Witberg Wind Energy Facility and associated infrastructure, Western Cape Province

Motivation for amendment of Environmental Authorisation

DEA Ref.: 12/12/20/1966/AM6

November 2018

Figure 2.1: The updated 25 wind turbine wind farm layout for the Witberg Wind Energy Facility (A3 Map included in **Appendix J**).

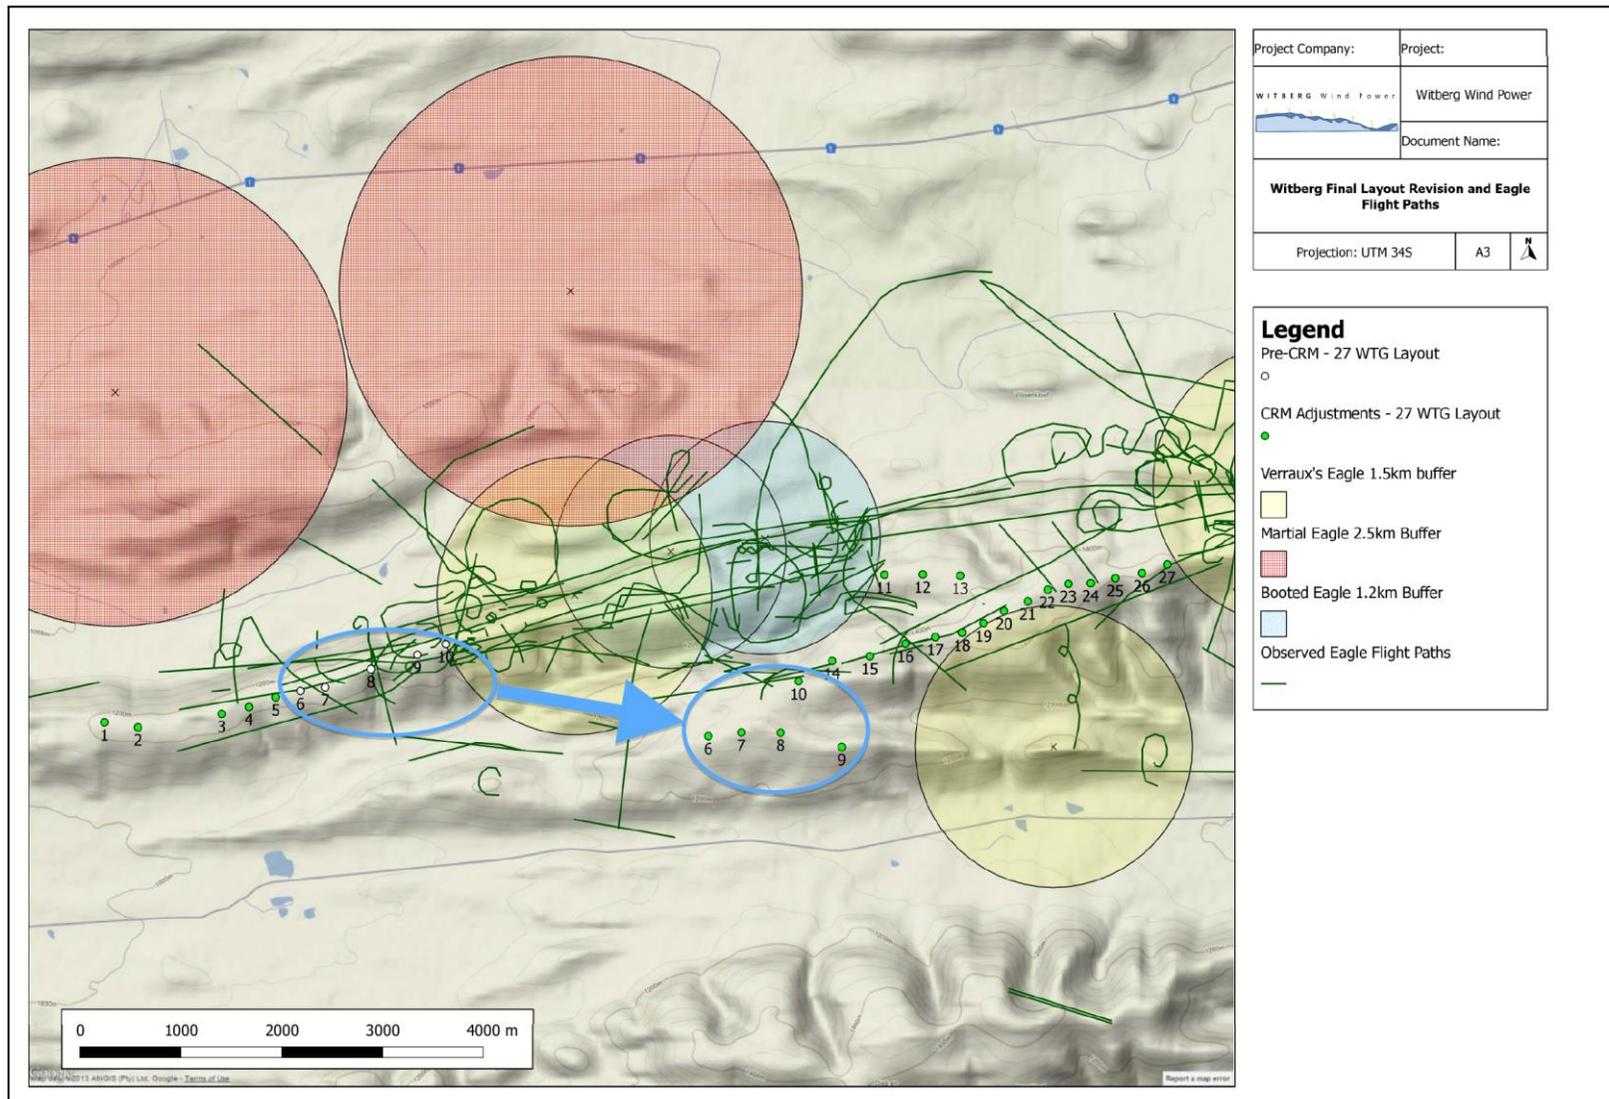
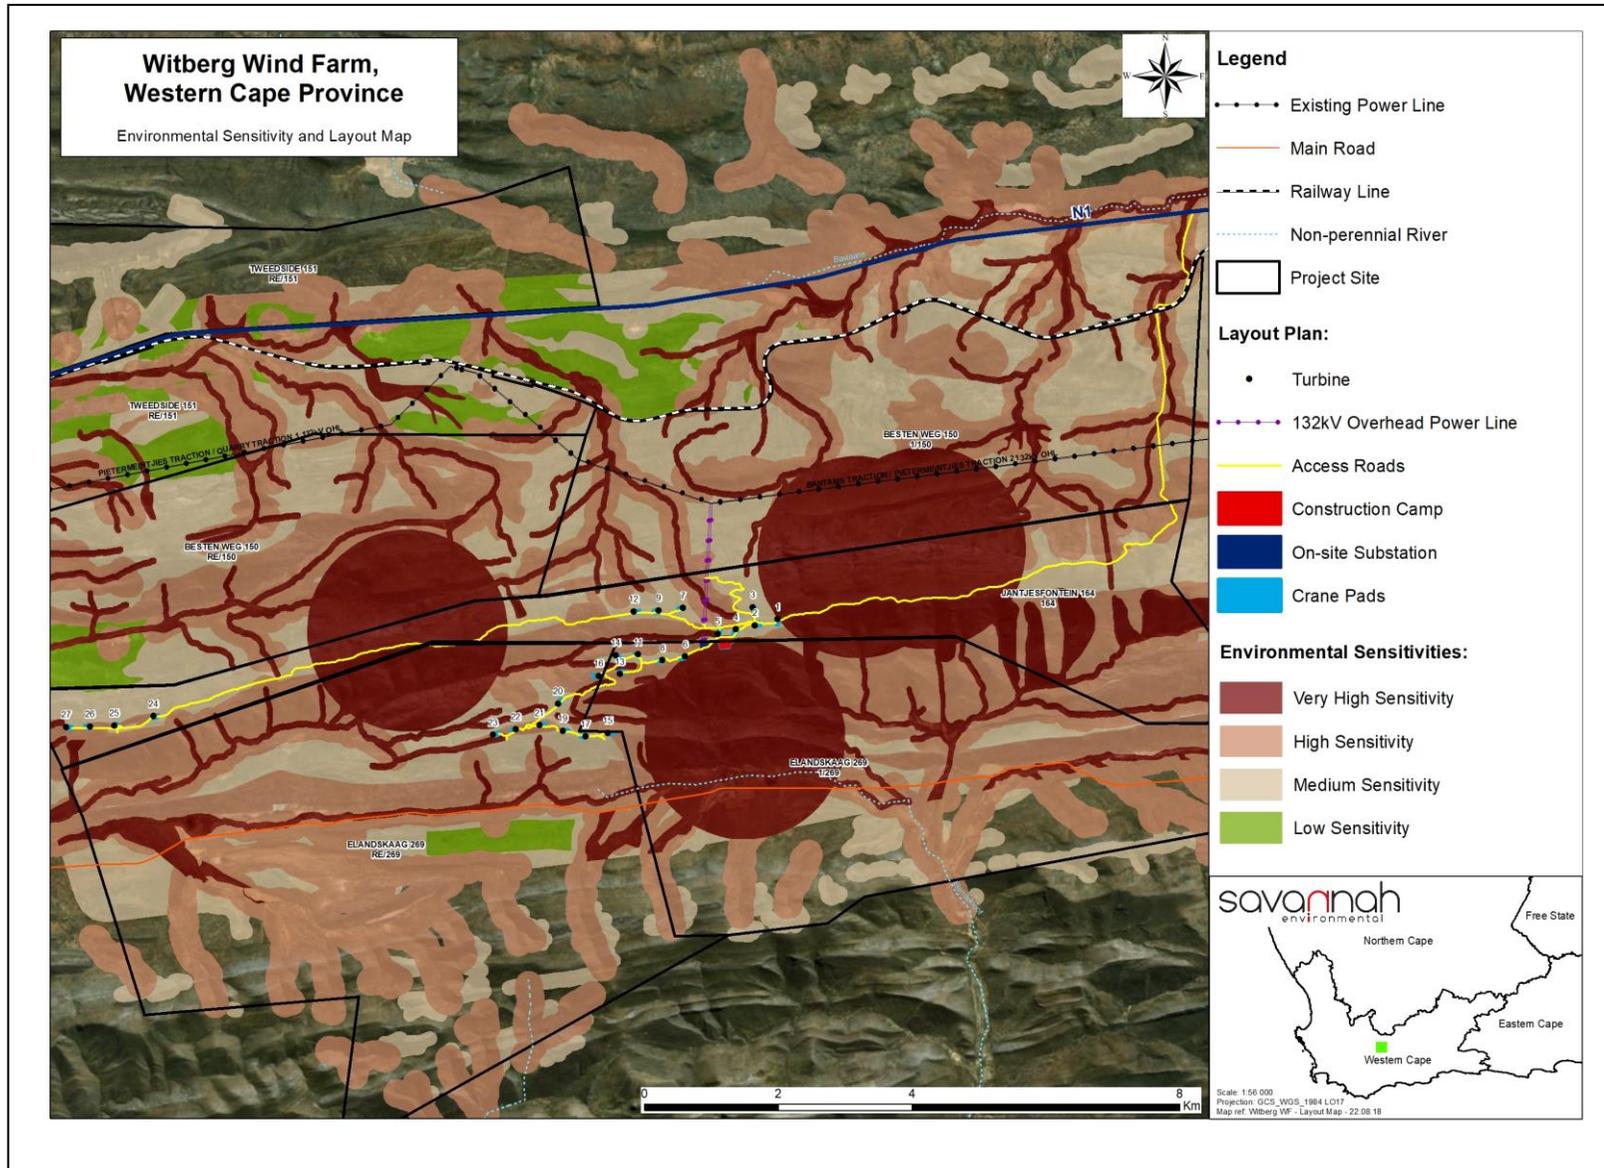
As per the appeal decision, Substitute Condition 1 approves Layout Revision 7. This layout illustrates the approved 27 wind turbines that were revised following the said appeal. The applicant is currently requesting that the layout be amended in order to avoid identified sensitive areas and optimise the layout. The approved Layout Revision 7 did not take full account of the Verreux Eagle nest 1.5km buffer and bat sensitivities. As such, the wind turbine layout has been reduced from 27 turbines to 25 wind turbines, and the wind layout and associated infrastructure have also been re-positioned to take into account the sensitivities. Additionally, the construction camp, substation and associated 132kV overhead power line have been re-positioned to optimise the layout. Approval of the amended wind farm layout is therefore requested.

The updated layout considering these amendments is illustrated in **Figure 2.1**. The sensitivity areas shown are classified as follows:

Figure 4.1: Bat sensitivity map in relation to the currently authorised layout, western cluster of turbines (turbine 4 in high sensitivity buffer).

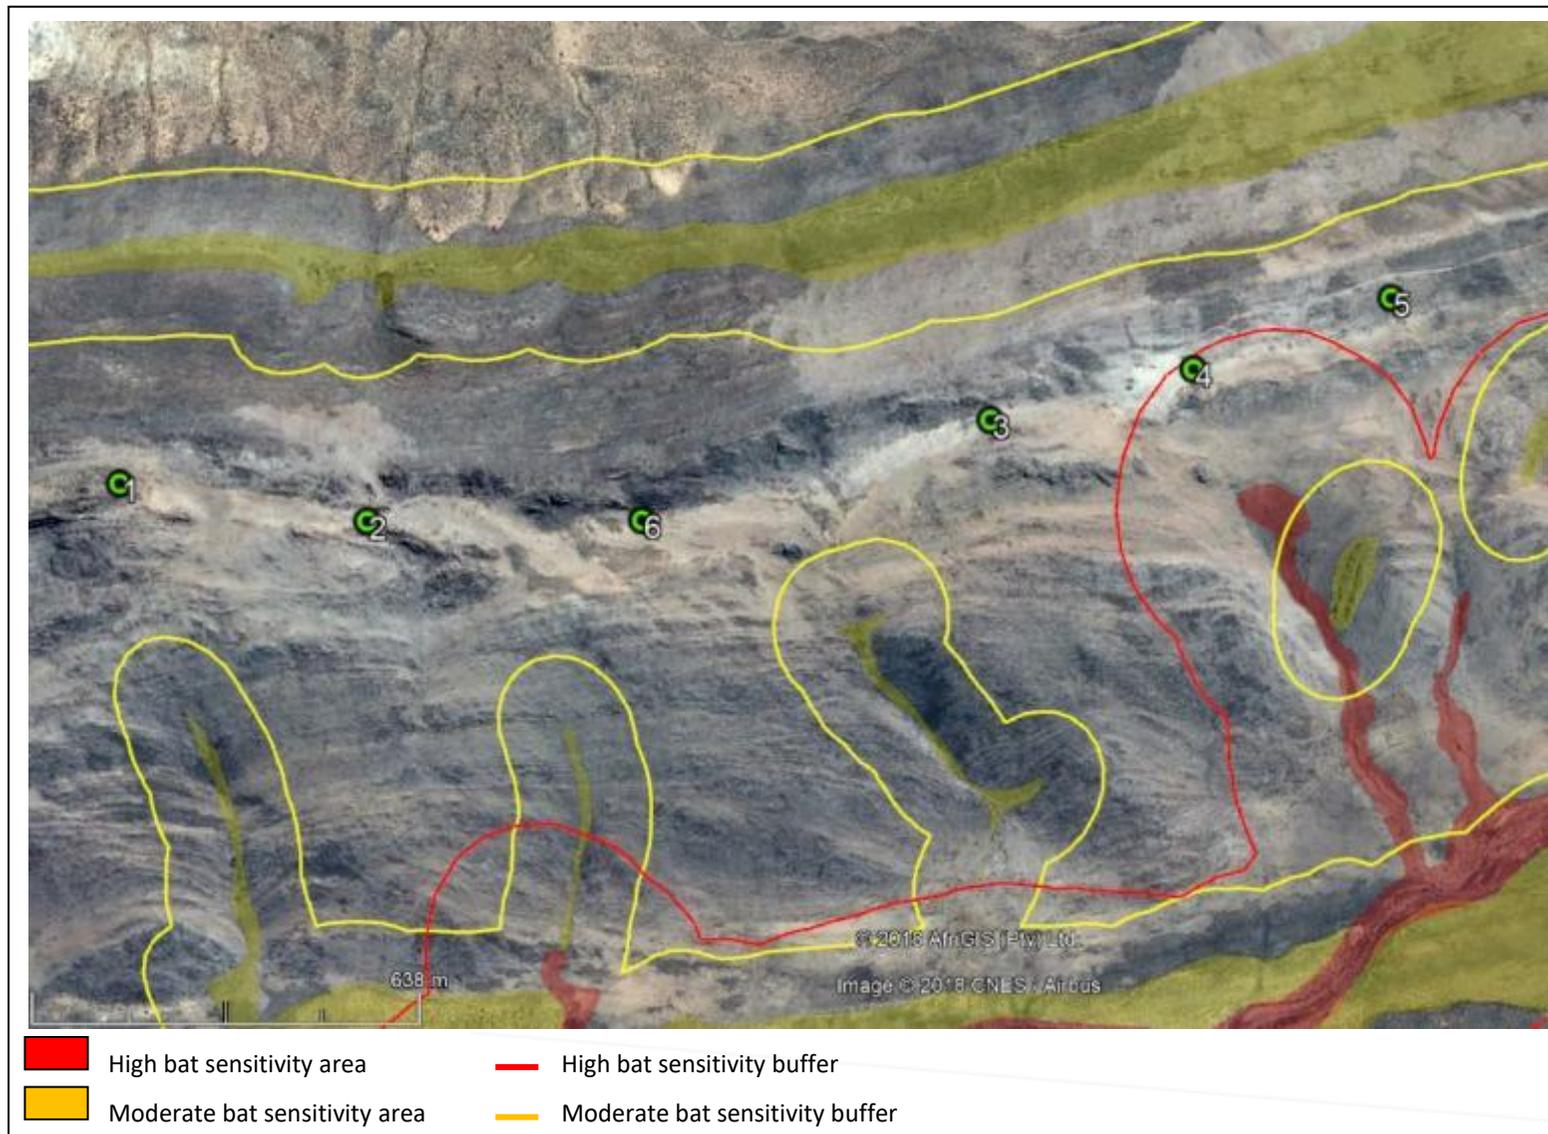
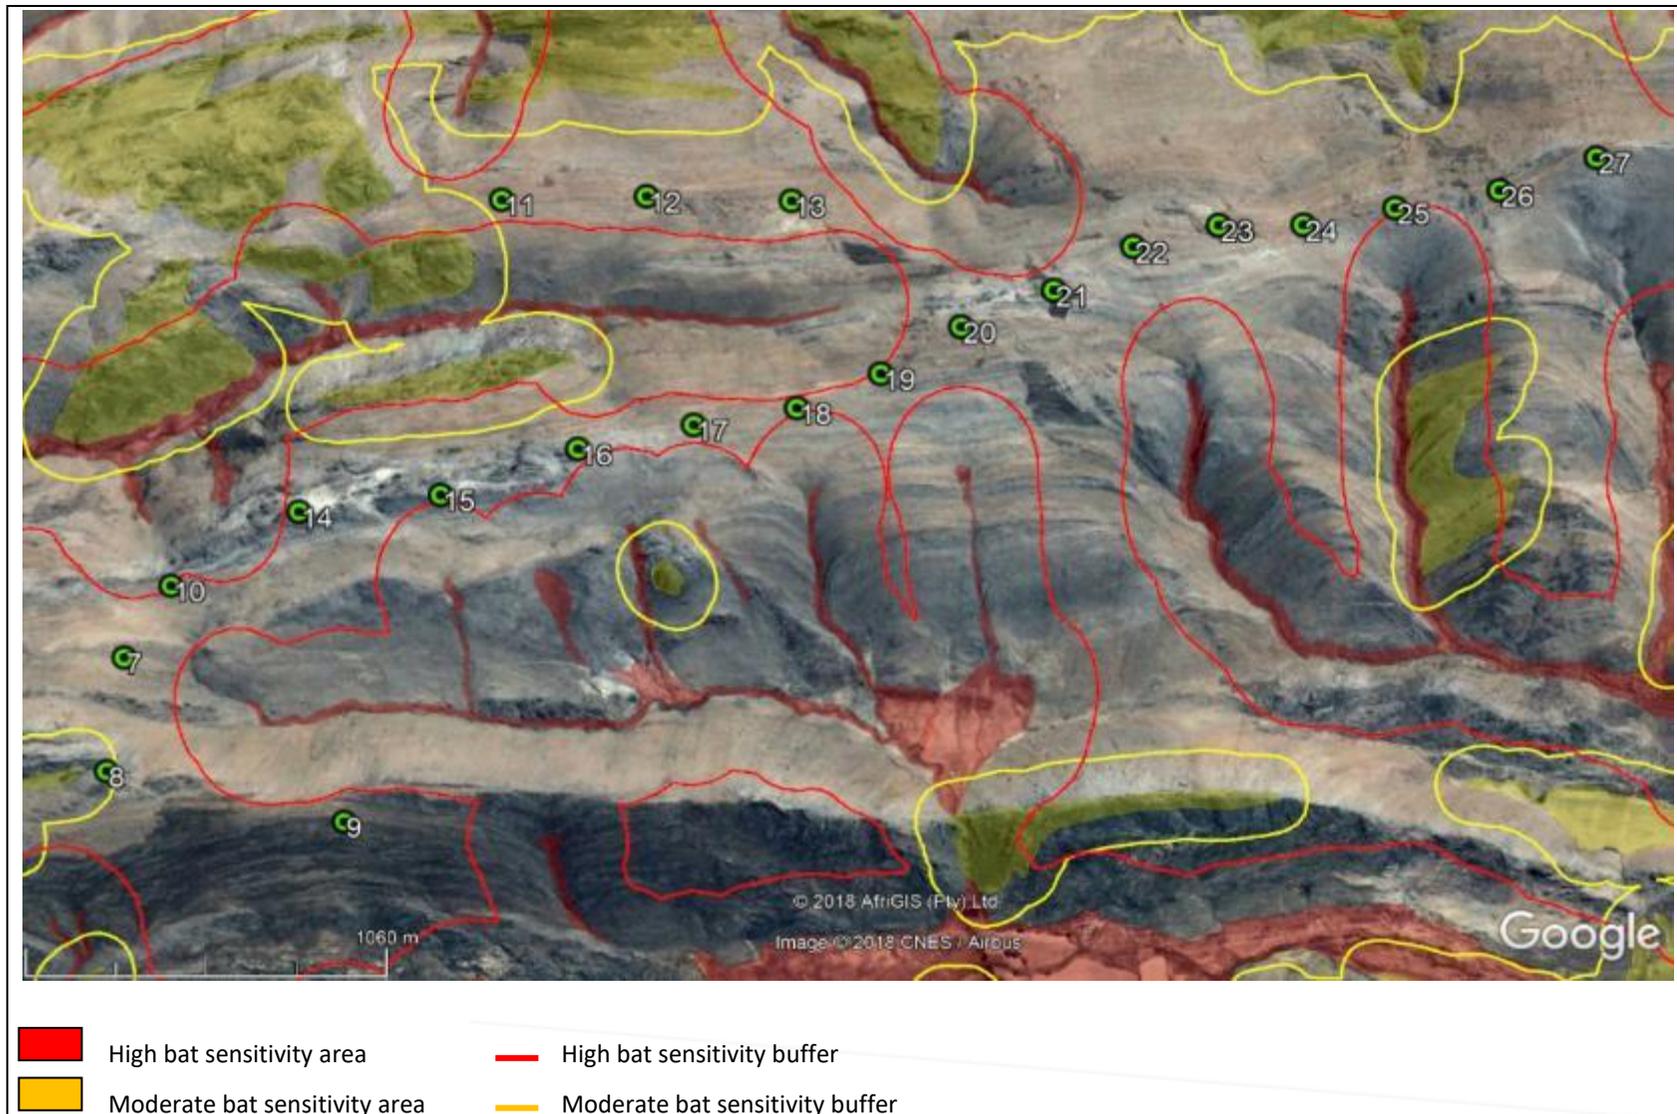
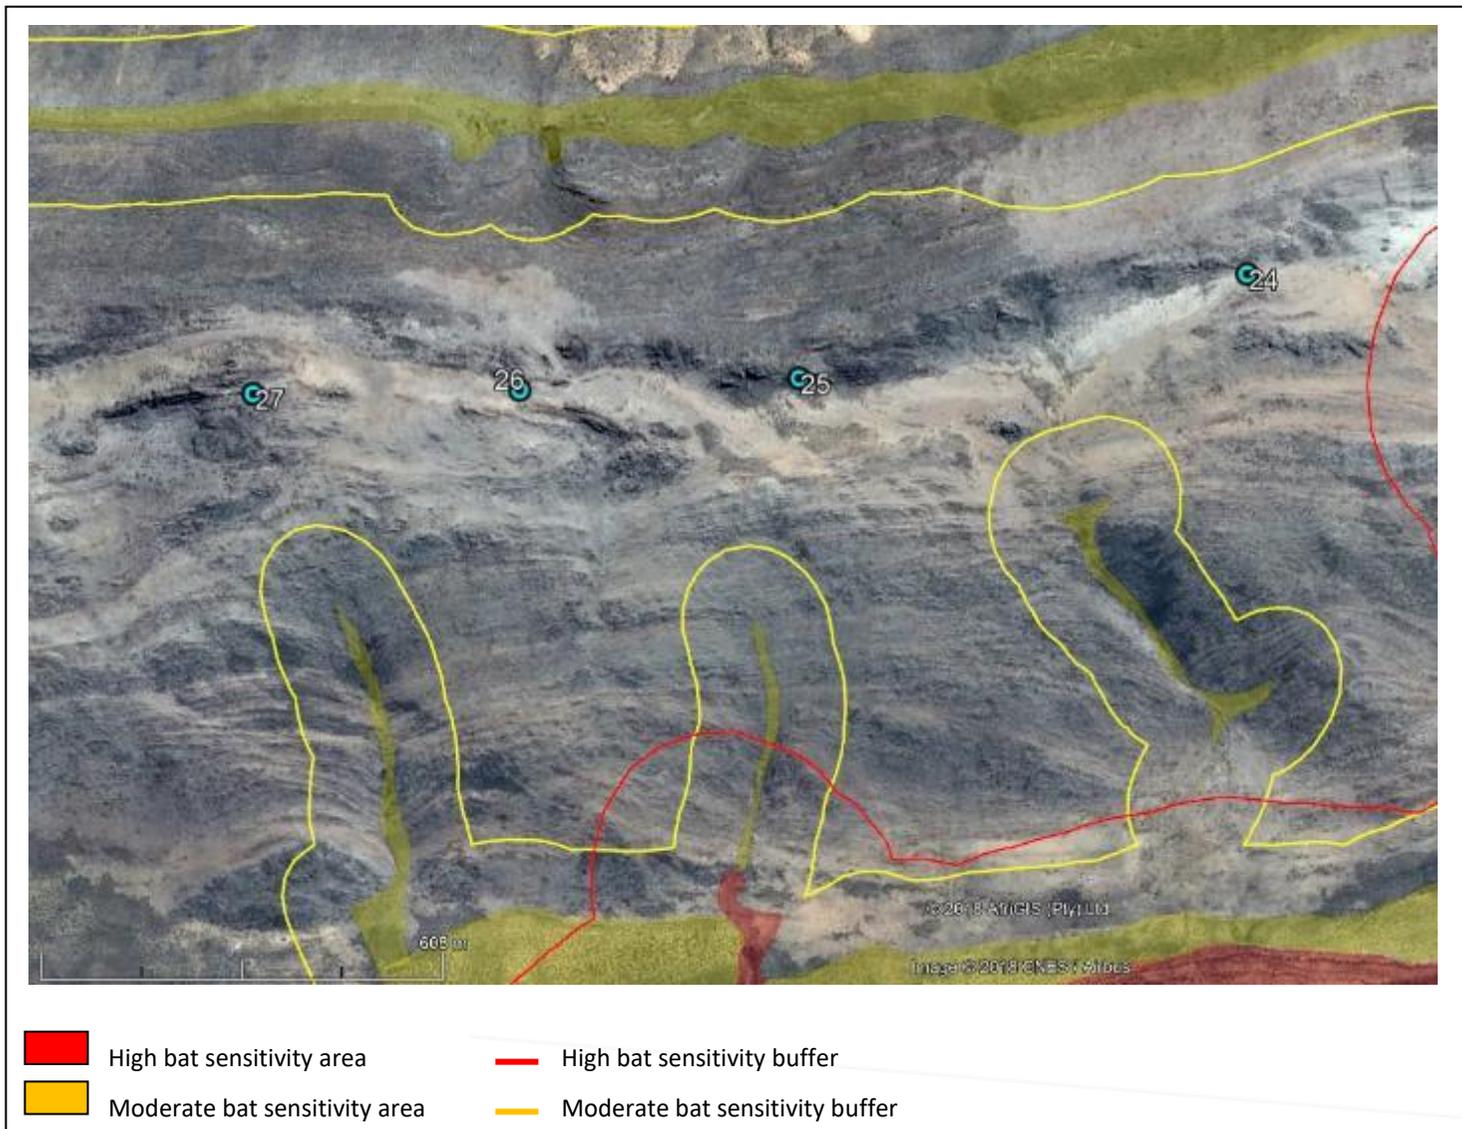
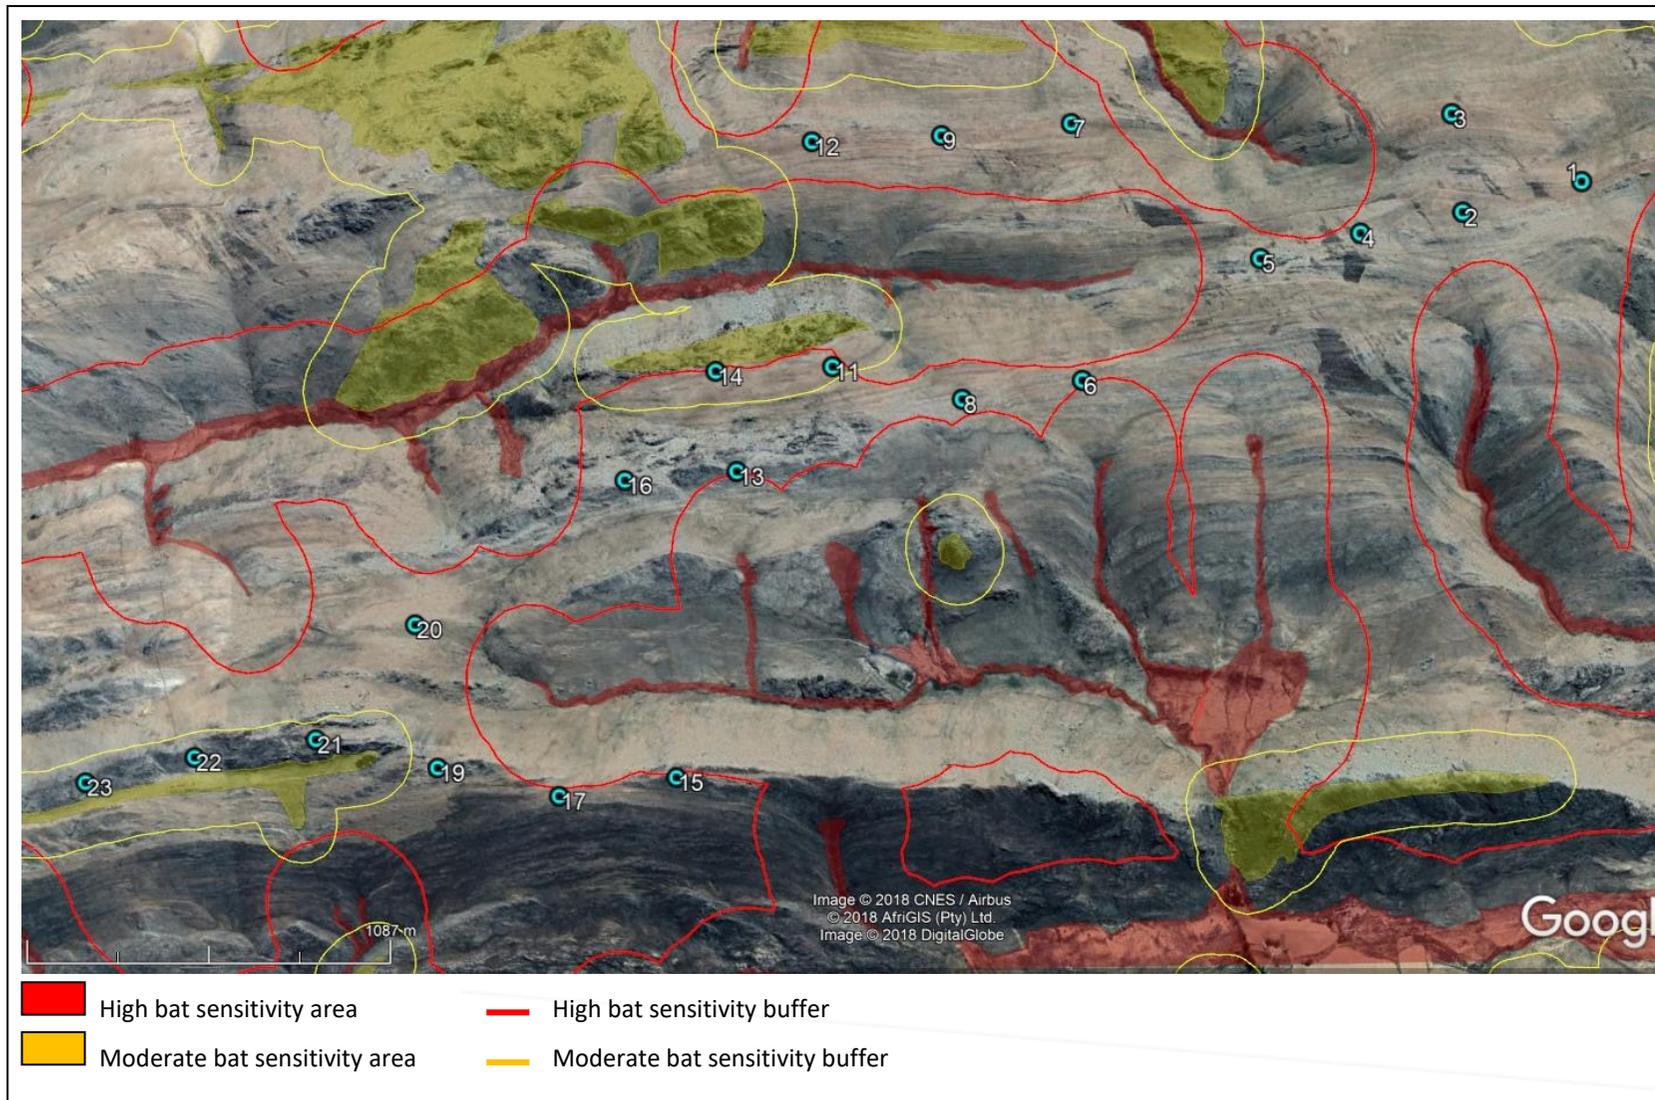
Changes in the layout of the associated infrastructure will have a negligible effect on the significance of impacts identified in the original EIA bat report dated 2011. However, the proposed change in the turbine layout will decrease the significance of impacts originally identified in the EIA bat report dated 2011 for the operational phase. The currently authorised layout (Layout Revision 7 as per appeal decision LSA 105-439, dated 13 August 2013) has 1 turbine inside a high bat sensitivity buffer and 1 turbine in a moderate sensitivity buffer. The proposed layout has no turbines in high sensitivity buffers and 5 turbines inside moderate sensitivity buffers (Table 3 and Figures 4.1 – 4.). Due to the high significance and importance of high bat sensitivity areas and their buffers, they are prioritised over moderate sensitivity buffers.
